**Application for Gatwick Airport Limited seeking Development Consent for the
Proposed Gatwick Airport Northern Runway Project (ref: TR020005) – Response to
consultation letter dated 3 January 2025**

Title	Noise Response to Secretary of State's Letter		
Project	Gatwick Airport DCO		
Reference	28AD.NT.10.0	Author(s)	BHo
Date	10 January 2025	Reviewer	VC

CAGNE Response to Consultation 2: Proposed Requirements

7.5 Figure 5 – Cumulative distribution for 16hr L_{Aeq} (0700 – 2300)

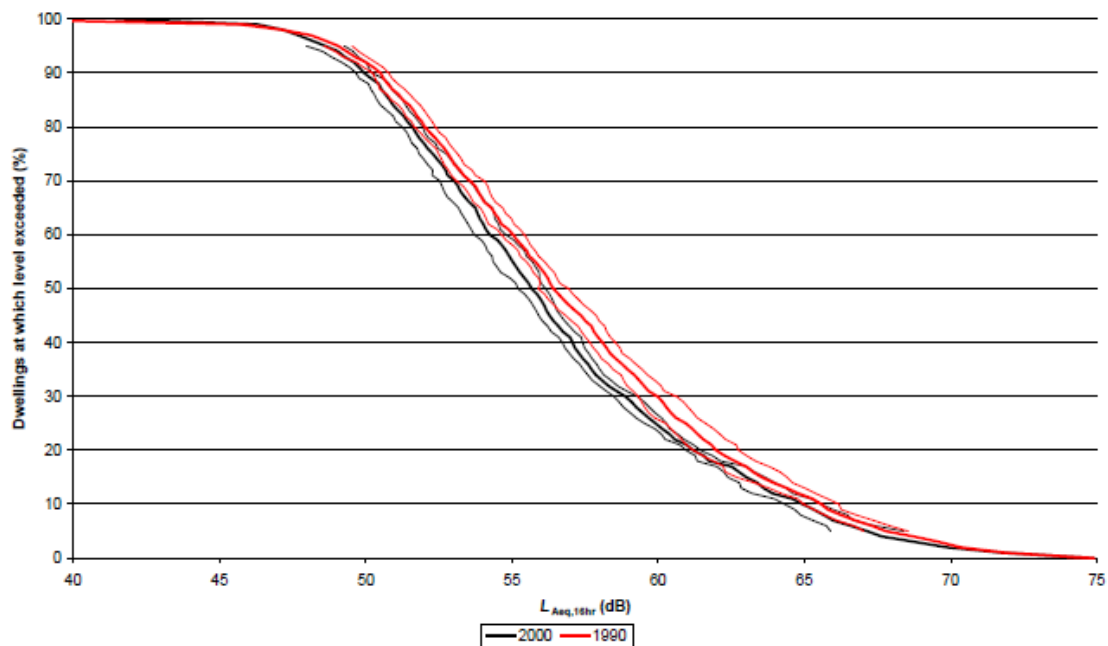
18. The BRE National Noise Incidence Study from 2000 sets out the most recent survey of national noise levels. Figure 7.5 from that report provides the statistical information on the range and incidence of ambient noise levels throughout the country in the form of a cumulative distribution of daytime (07h00 to 23h00) L_{Aeq} noise levels, as can be seen below.

19. Were Gatwick to not include premises where noise levels are in line with the thresholds proposed (51 dB $L_{Aeq,16hr}$), the above figure suggests that over 90% of all premises might not be eligible.

20. It is unacceptable to omit more than 90% of premises on the basis that they already experience some level of noise.
